AIRWORTHINESS OPERATOR MESSAGE

Ref AOM: 2022/04 issue 3

AIRCRAFT MODELS: All ATR42 and ATR72 models

SUBJECT: Contactor 1PA operational test

2. Operational test flowchart

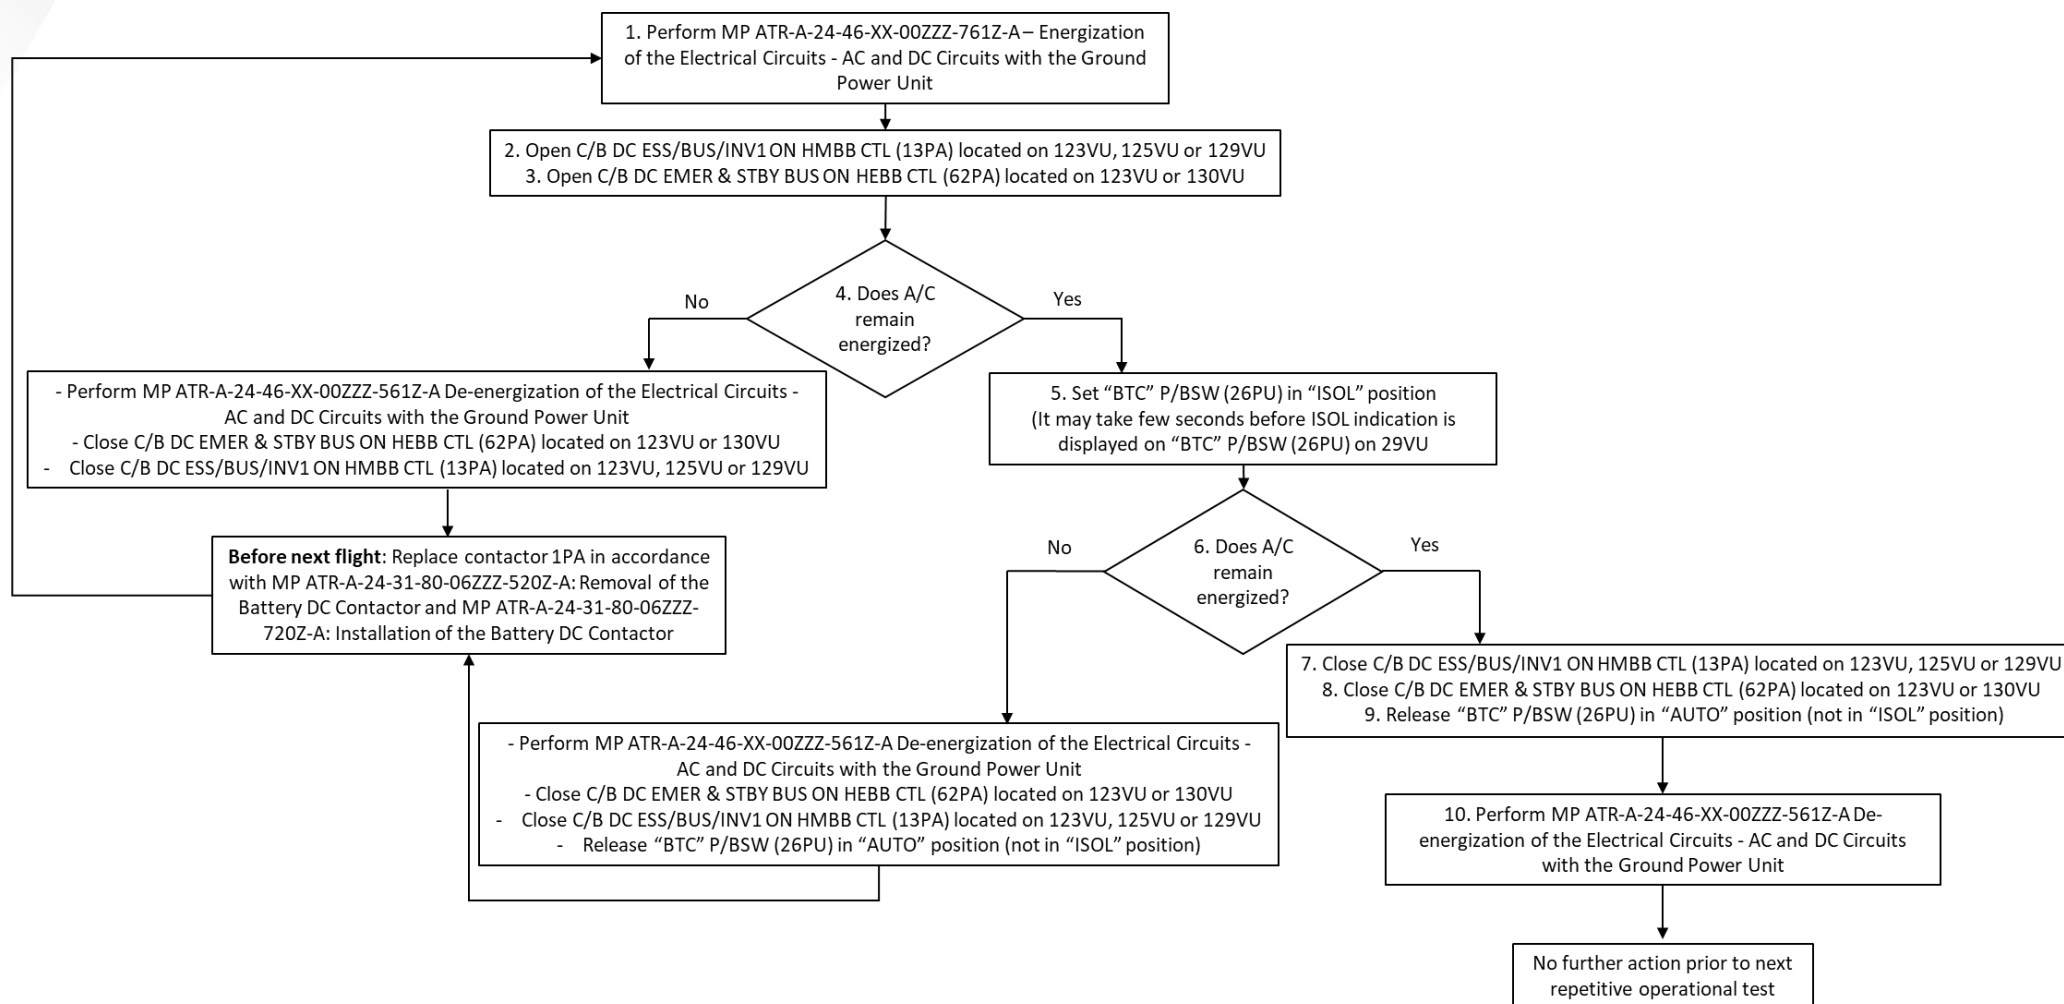
This AOM is revised to issue 3 to correct the Operational test flowchart in Appendix 1 by removing the step 11, in accordance with the procedure.
